Staff Review Comments

AUB info on fire hydrant

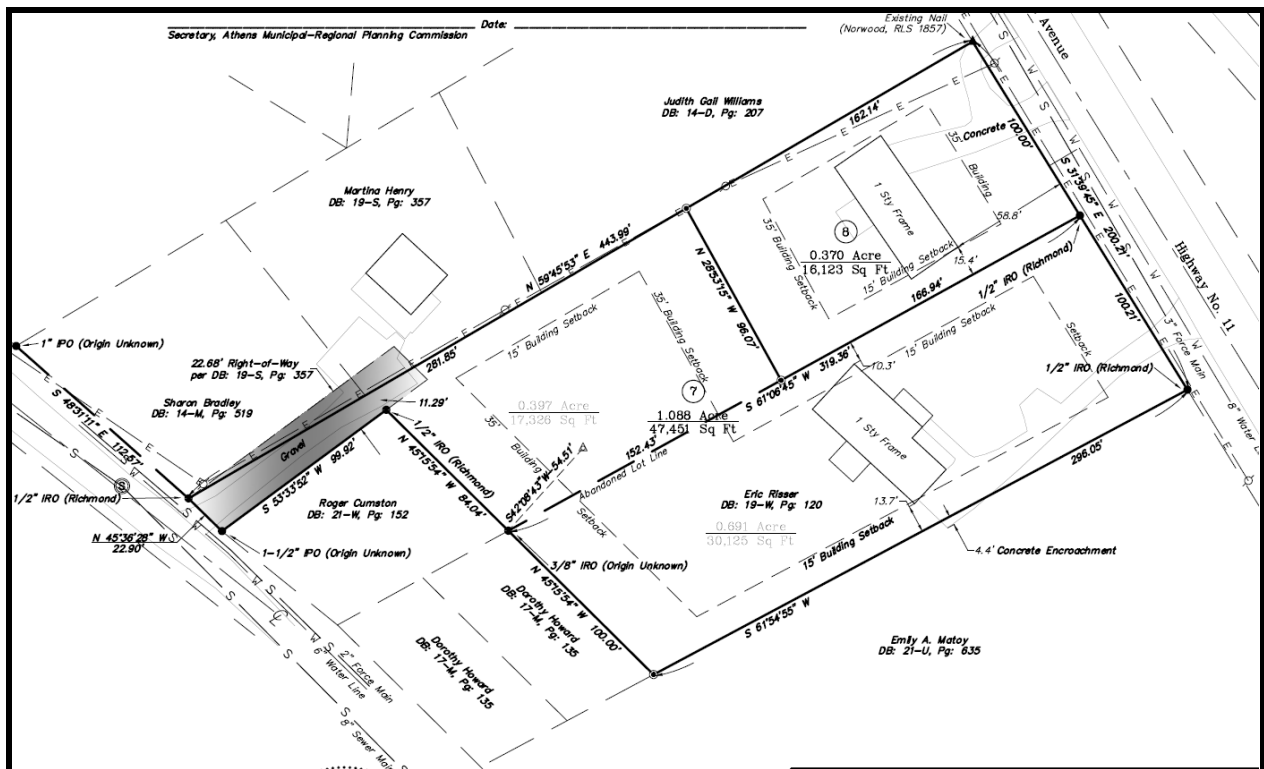
- If infrastructure is available to support it, a fire hydrant will need to be installed. (Note: I have asked AUB if infrastructure is available and am waiting for a response. I will update you as soon as they provide me additional information.)

- This location is not well suited for driveways as site distance is minimal due to a crest vertical curve along Highway 39 where these lots are planned. If approved as is, there is nothing TDOT can do to improve this condition.
- It would be preferable to have a roadway entering the property at a location with better sight lines which all parcels could access from the interior of the property, especially if any further development of this property is planned in the future.

At that location we have:

- 6" water main right in front of these lots.
- No sewer.
- 2" gas line across the street
- VEC's power

As for the locations of FHs, we let that up to the you. We just determine the specs of what type to use, and if we have the pressure and flow to supply them.

That location is near the end of our line, but we did install a FH last September about 3,000 ft past this location headed south in front of the Faith Baptist Tabernacle Church. It had a static pressure reading of 110 psi and flowed 850 gpm @ 30 psi. I'd figure that a FH in front of these 3 lots that are about 32 ft higher in elevation than the other FH, we would have a static pressure reading of around 95 psi and would flow 838 gpm at 20 psi, or 65 psi at 500 gpm. So we're good to go.

The owner would need to come by our offices and talk to our CSRs about having AUB install a FH at that location. They would need a street address and the ability to pay the \$4,000 FH charge for setting the FH. We of course would want to look at it to make sure we don't have to do anything extra during the installation that would cost them more.
